ECOLOGICAL ADVICE SERVICE

TO: David Campbell
FROM: Emma England
DATE: 02 October 2024
SUBJECT: 24/0700/FH/CON / Maude Memorial Hall, New Romney

CONDITION DISCHARGE – ADDITIONAL INFORMATION REQUIRED

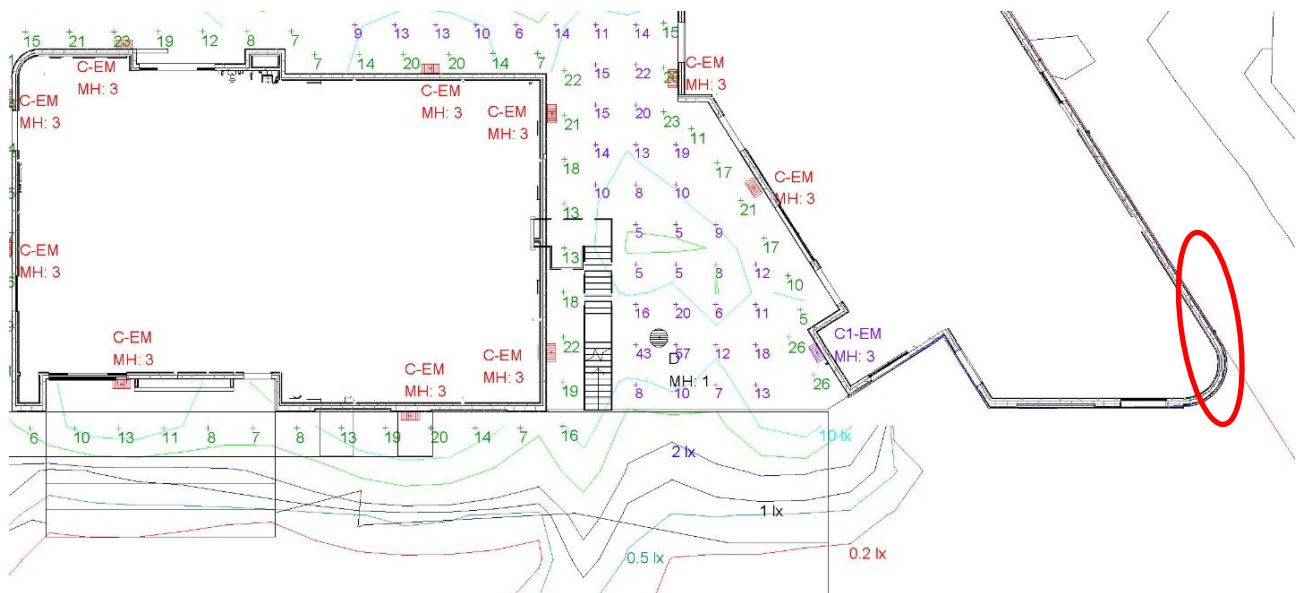
We note a lux level contour plan has been provided (but is not currently showing on the public register for application 24/0700/FH/CON) with a maintenance factor of 0.9 and lighting of 2700K. The lux levels provided are assumed to be at ground level on the horizontal plane although we cannot see that this is clearly stated anywhere. This plan (Lux Works E53272/PJ/A dated 22nd July 2024 for Maude Pavilion and Nursery Romney) indicates that lighting around the roost (assumed at ground level) will be between 13 and 18 lux, with the likely (lit) flight path(s) between 0.2 lux and 22 lux. Lighting levels at day 1 of operation are expected to be higher, and current guidance indicates that lighting plans that need to take into consideration bats, should provide lux level contour plans using a maintenance factor of 1¹.

The bat that was previously recorded as roosting on-site was a soprano pipistrelle bat. Soprano pipistrelle bats generally fly approximately 2-10m above ground level². Lighting levels at 2m+ have not been provided. Light levels around the bat box itself have not been provided. Relevant light levels for the bat box would likely be those levels on the vertical plane at and around the bat box entrance.

Illuminating a bat roost can cause disturbance and this can result in bats deserting (or never using) the roost and delay emergence, reducing foraging time available. The flight path to and from the roost is important, although soprano pipistrelle bats are recorded as less sensitive to lighting of their flight paths than they are to the lighting of their roosts³. Soprano pipistrelle bats are less vulnerable to the negative impacts of lighting than some other species of British bat. Soprano pipistrelle bats may be able to cope with lighting levels up to 5 lux⁴ along foraging routes.

Current available information (although limited) indicates that the proposed location of the bat box, when lighting is taken into consideration, means that it is unlikely to be used. The simplest solution may be to move the proposed bat box to a more suitable location, or provide an additional bat box in an alternative location. We would recommend that an integrated bat box is provided on the south/ south-east facing elevation of the nursery building, as far away from windows as possible and to a height of over 3m from ground level (ideally 4-5m from ground level). Suggested location(s) shown below by the red circle:
